MONTGOMERY COUNTY HISTORIC PRESERVATION COMMISSION
STAFF REPORT

Address:	9 Primrose St., Chevy Chase	Meeting Date:	07/11/2018
Resource:	Contributing Resource Chevy Chase Village Historic District	Report Date:	07/05/2018
Applicant:	Alice and Peter Keating (Chris Snowber, Architect)	Public Notice:	06/27/2018
Review:	HAWP	Tax Credit:	No
Case Number:	35/13-18U	Staff:	Michael Kyne
PROPOSAL:	Window and door alterations

Image from 1949 F.H.M. Klinge Property Atlas (Subject Property Circled in Red)

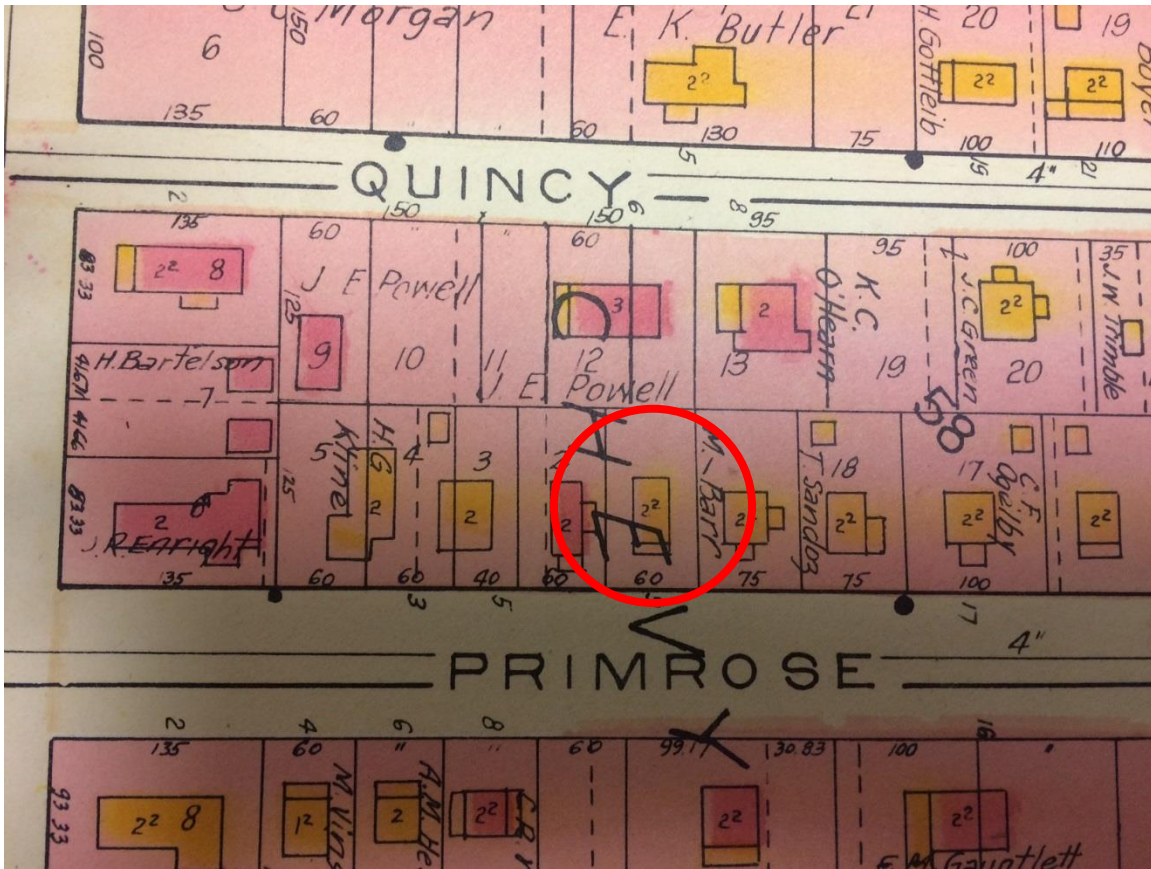
The subject property is a c.1892-1916 Craftsman/4-Square-style Contributing Resource within the Chevy Chase Village Historic District. According to the 1949 F.H.M. Klinge property atlas (see below), the structures at the rear are not original to the house. The applicant's architect has stated that the rearmost addition appears to be consistent with 1950s construction materials and methods, and that the addition in the northwest/rear corner has experienced alterations as recent as the 1980s. There is also a one-story mudroom addition on the northeast/rear corner, which dates to the 1980s.
